Class II Change Letter

This is to declare that our product, FCC ID: **S4LONE (Class II Change)**

This product is an extend of original one reported under Sporton project number: 592307. There is no change on the RF module, so only Conduction emission and Radiation emission was tested.

Modification Description

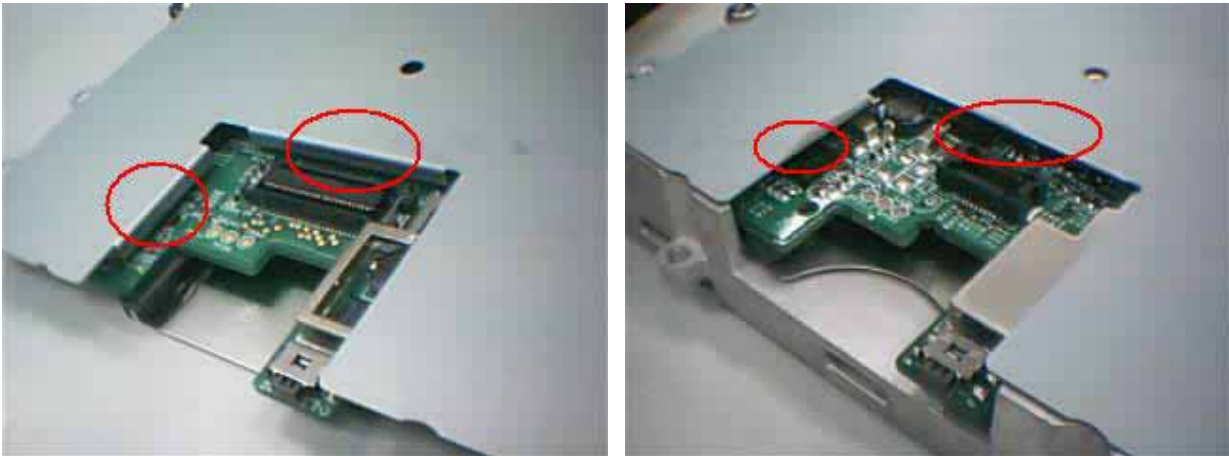
Difference 1: Remove the hook on cover: 6053A0095201(G)→6053A0095202(A)

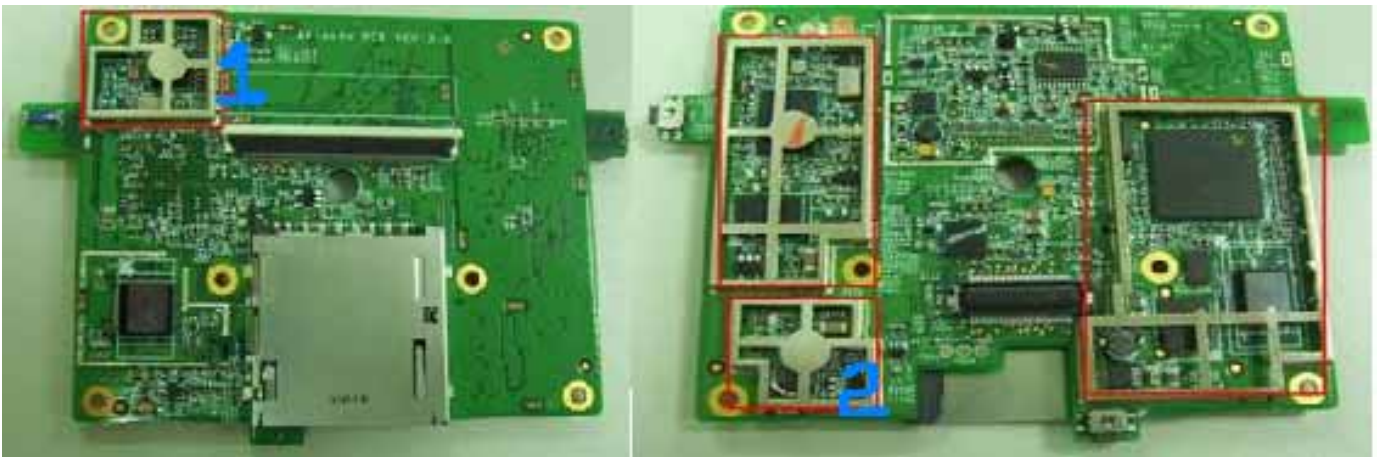
Difference 2: Remove the Atlanta Main Board Cover (Blue 1,2)
